PTAC Union Square Walk Audit (April 2025)

City of Somerville Responses
November 20, 2025

Union Square – Walk Audit

Key Area 6 – Bow Street (Walnut Street Intersection)

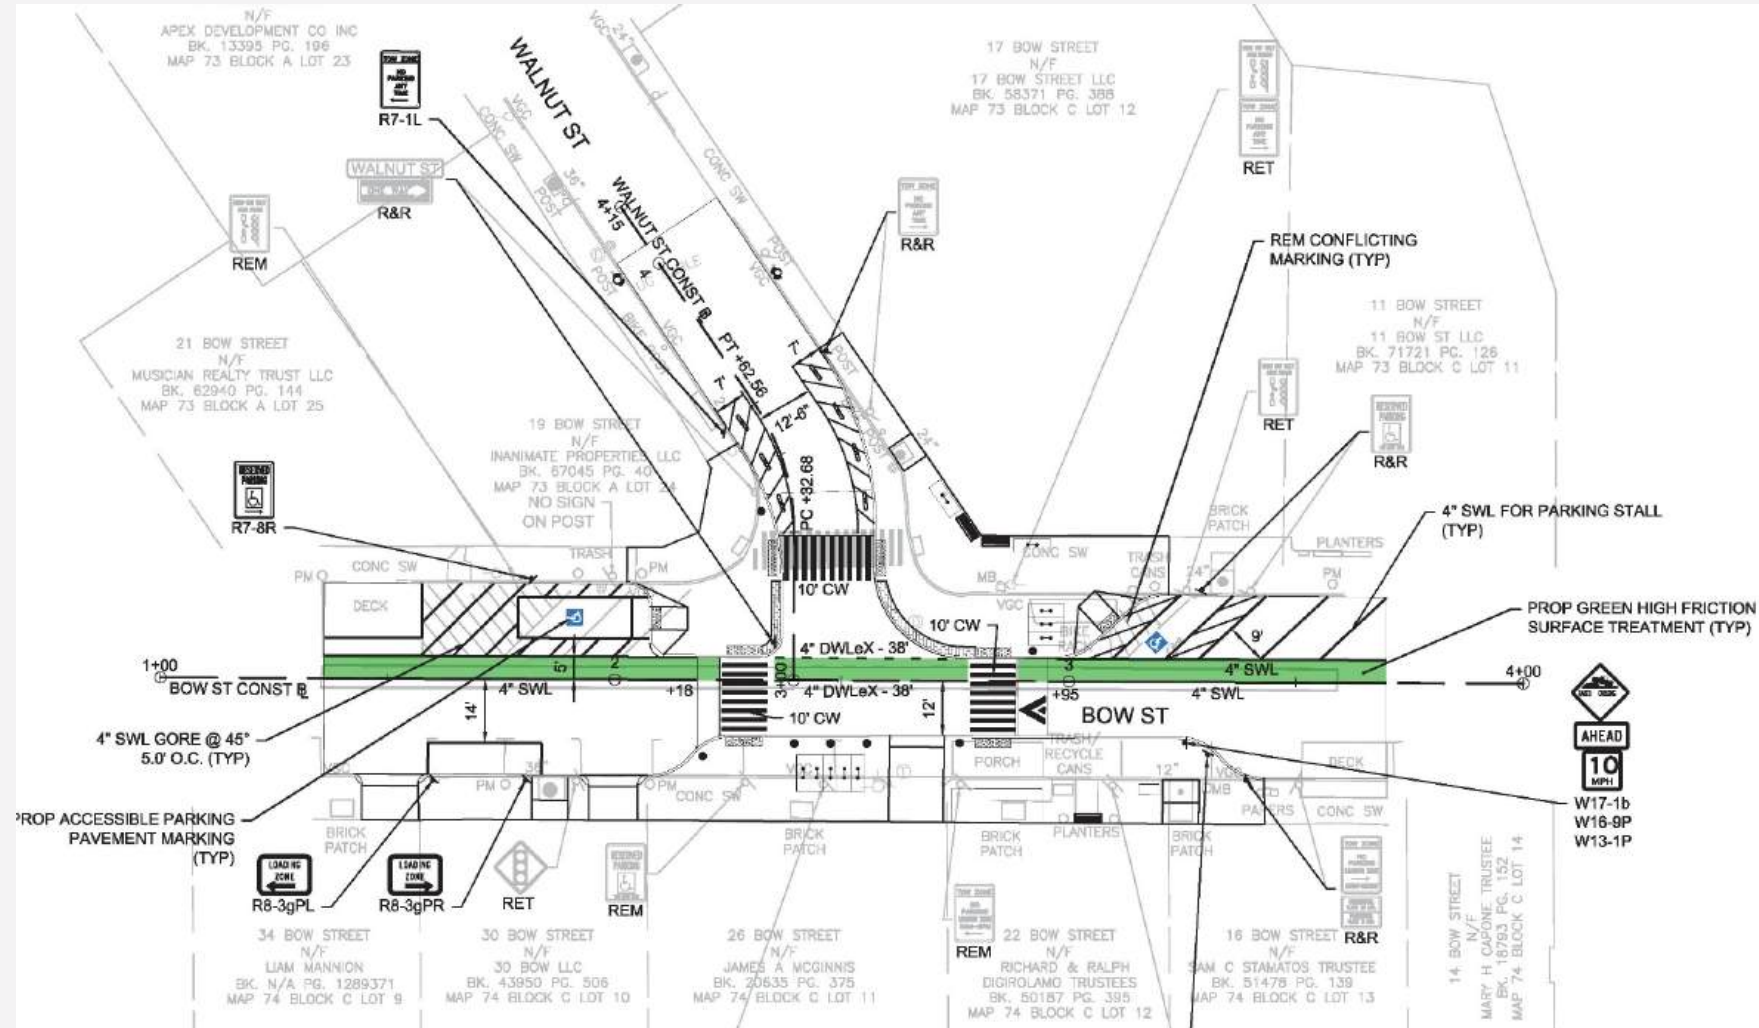
*Install tactile pads at the crossing where missing.
Repaint crosswalk markings were faded.*

- The Walnut Street/Bow Street intersection will be reconstructed to a fully raised intersection including all new tactile pads, curb extension to shorten crossing distance, and newly painted crosswalks (project is scheduled for construction start Spring 2026).
